07-15-21 - CITY COMMENTS	
--------------------------	--

HOMWOOD SUITES
3500 S. MERIDIAN
SOUTH HILL MALL
PUYALLUP, WA 98373

OFFSITE ADA RAMP IMPROVEMENTS DEMOLITION PLAN
C-3.1

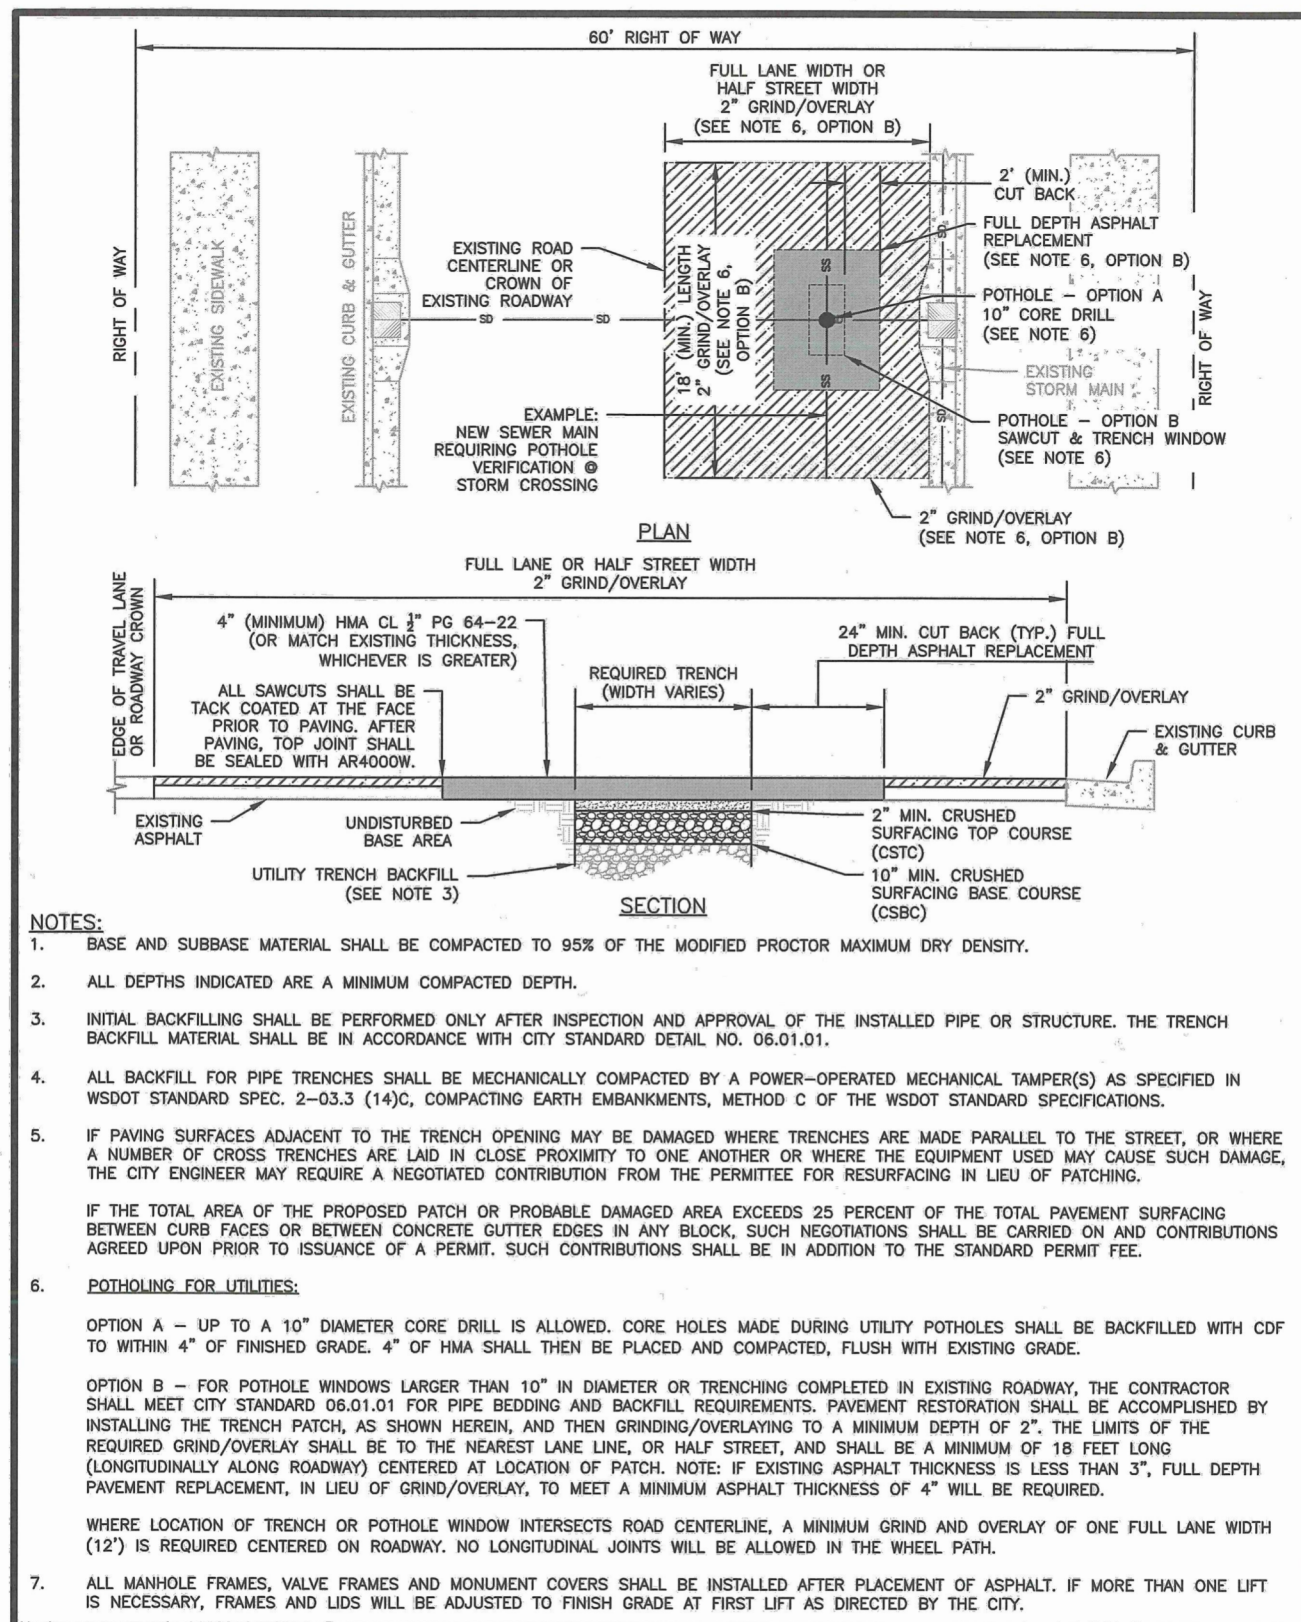
SHEET C5.4 - On the southeast corner of the intersection, the intent of the design between the landing and the north match existing joint is unclear as to which of the three sections is ramp and which of the three are sidewalk. The curb and gutter top elevations are at 399.10ME, 399.54TC, 399.04FL, 399.52TW/ME, 399.37TW/ME, 399.50TW, 399.53TC, 399.56TC, 399.06TW, 399.57TC, 399.07TW, 399.61TC, 399.69TW, 399.80TW/ME, 399.70TC/ME, 399.20FL/ME, 399.62TC, 399.12FL, 399.23ME. The curb and gutter top elevations are at 399.10ME, 399.54TC, 399.04FL, 399.52TW/ME, 399.37TW/ME, 399.50TW, 399.53TC, 399.56TC, 399.06TW, 399.57TC, 399.07TW, 399.61TC, 399.69TW, 399.80TW/ME, 399.70TC/ME, 399.20FL/ME, 399.62TC, 399.12FL, 399.23ME. The curb and gutter top elevations are at 399.10ME, 399.54TC, 399.04FL, 399.52TW/ME, 399.37TW/ME, 399.50TW, 399.53TC, 399.56TC, 399.06TW, 399.57TC, 399.07TW, 399.61TC, 399.69TW, 399.80TW/ME, 399.70TC/ME, 399.20FL/ME, 399.62TC, 399.12FL, 399.23ME.

SHEET C-5.4 - 3 of 4 ramps do not include running slopes. Provide conforming slopes for all ramps.

SHEET C5.4 - The elevation shown on the southeast corner of the intersection for the back of sidewalk TC at the north end of the ramp is 399.65TW/ME. The elevation shown on the southeast corner of the intersection for the back of sidewalk TC at the south end of the ramp is 399.85TW/ME. The elevation shown on the southeast corner of the intersection for the back of sidewalk TC at the north end of the ramp is 399.65TW/ME. The elevation shown on the southeast corner of the intersection for the back of sidewalk TC at the south end of the ramp is 399.85TW/ME.

SHEET C5.4 - The elevation shown on the southeast corner of the intersection for the back of sidewalk TC at the south end of the ramp is 399.85TW/ME. The elevation shown on the southeast corner of the intersection for the back of sidewalk TC at the north end of the ramp is 399.65TW/ME. The elevation shown on the southeast corner of the intersection for the back of sidewalk TC at the south end of the ramp is 399.85TW/ME. The elevation shown on the southeast corner of the intersection for the back of sidewalk TC at the north end of the ramp is 399.65TW/ME.

SHEET C-5.4 - Check the flow line elevations at 399.65TW/ME and 399.85TW/ME.
